MOONEY SPECIAL LETTER 15-17
Date: 9-21-2015

SUBJECT: To ADVISE MOONEY OWNERS/OPERATORS of the **LYCOMING Service Bulletin No. 621A (Supersedes Service Bulletins No. SB-621) Issued September 2, 2015 - Diaphragm-Type Fuel Pump Replacement (see attached).**

DATE: September 2, 2015 Service Bulletin No. 621A
(Supersedes all versions of Service Bulletin No. 621)
Engineering Aspects are
FAA Approved

SUBJECT: Diaphragm-Type Fuel Pump Replacement

Figure 1
Manufacturer's Code Location on
Fuel Pump P/Ns 62B26931 and LW-16335

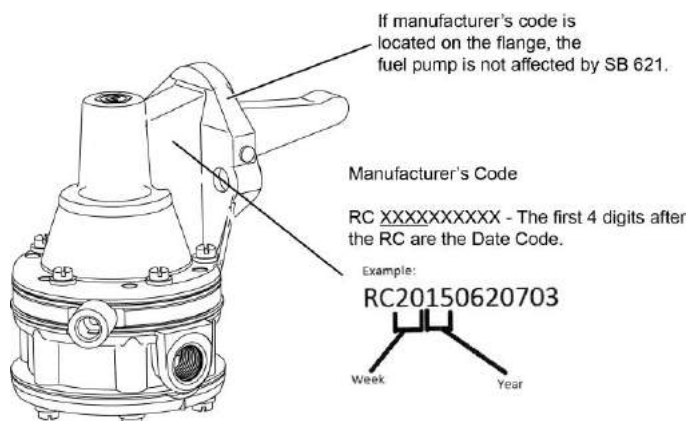
NOTICE: Each fuel pump has a 13-digit alphanumeric manufacturer’s code, which begins with two letters as shown in the example in Figure 1. The alphanumeric characters in the manufacturer’s code and its location on the fuel pump will help identify the fuel pumps affected by this Service Bulletin. The first two characters in the example manufacturer’s code RC20150620703 in Figure 1 are **RC**. The next two numbers **20** identify the manufacturing week of the year as **20** and **15** is the year. The manufacturer’s code is on the fuel pump flange or on the web as shown in Figure 1. If the manufacturer’s code is on the flange as in the example in Figure 2, the fuel pump is not affected by this Service Bulletin.

1. If the fuel pump is Lycoming part number 62B26931 or LW-16335.
2. If the manufacturer's code is not on the flange but is on the web or other parts of the fuel pump.
3. If the fuel pump has **RC** (Figure 1) as the first two letters of the manufacturer's code.
4. If the manufacturer's code identifies the fuel pump as manufactured before, up to, and including the 25th week of 2015.

If any fuel pump meets **all** the criteria above, remove the fuel pump from the engine or from the spares inventory and:

- A. Review your records to identify shipping dates of the serial numbers of any of the affected fuel pumps.
- B. Return all affected fuel pumps to Lycoming Engines with a copy of this Service Bulletin and file a warranty claim per the warranty procedure herein.
- C. Record removal of the fuel pump installed on the engine in the engine logbook.
